Access Compliance Report Public Rights-of-Way (RR Crossings)

Intersection ID: 51491	Main Street: N_TRYON_ST	Location: N/A
ADA ID: EC72B835D0C4	Overall Compliance: No	Severity Score: 0.0
Codes/Mitigation Info/Possible Solution		Field Measurements/Component Compliance

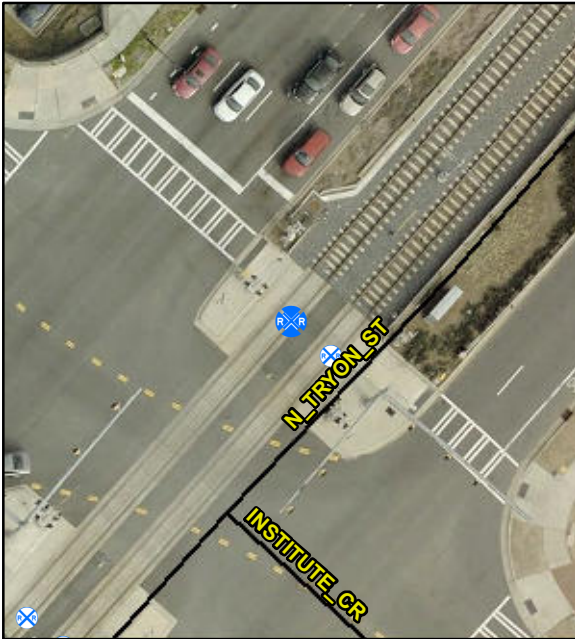
Compliance	Description	Data
No	DWS Provided?	No
N/A	DWS Contrast?	N/A
N/A	DWS Width (in)	N/A
N/A	DWS Length (in)	N/A
N/A	DWS Offset (in)	185.0
Yes	Pedestrian Gate?	Yes
N/A	DWS Outside Gate?	Yes
N/A	Rail Type?	LightRail
No	Flangeway Gap (in)	3.0
Yes	Sidewalk Width (in)	121.0

**Install Detectable Warning System.
Remove & Replace Walking Surface
Adjacent to Rail.**
